UNITED STATES PATENT AND TRADEMARK OFFICE

Office Action Summary

10/581,784

DETAILED ACTION

Fig. 3

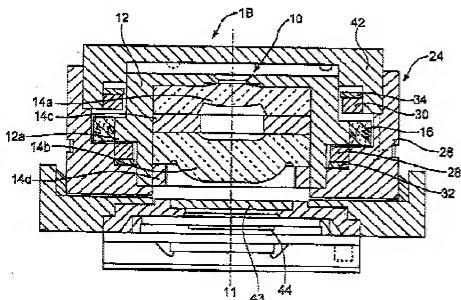
6. As to claim 1, Tsuruta discloses lens drive device comprising: a movable lens body (10) provided with a lens(14) (**abstract**), a drive means (16) for moving the movable lens body in an optical axis direction of the lens (0021, 0049, and 0066), and a fixing body (24) which movably supports the movable lens body in the optical axis direction (0051 and 0066), wherein the movable lens body is comprised of a lens-barrel provided with a lens and a lens-barrel holder which movably supports the lens-barrel in the optical axis direction (0021, 0048, and Fig. 3 or Fig. 1), the lens-barrel holder comprises a first magnetic means (16) as the drive means (0071 and Fig. 3), the fixing body (24) comprises a second magnetic means (32 & 34) as the drive means and a regulating part (36 more clearly labeled in Fig. 8) which regulates a moving range in the optical axis direction of the lens-barrel holder (0057, lines 9-15, 0059 and 0061), and the movable lens body is moved by a magnetic attractive force or a magnetic repulsive force between the first magnetic means and the second magnetic means (0057 and 0075).
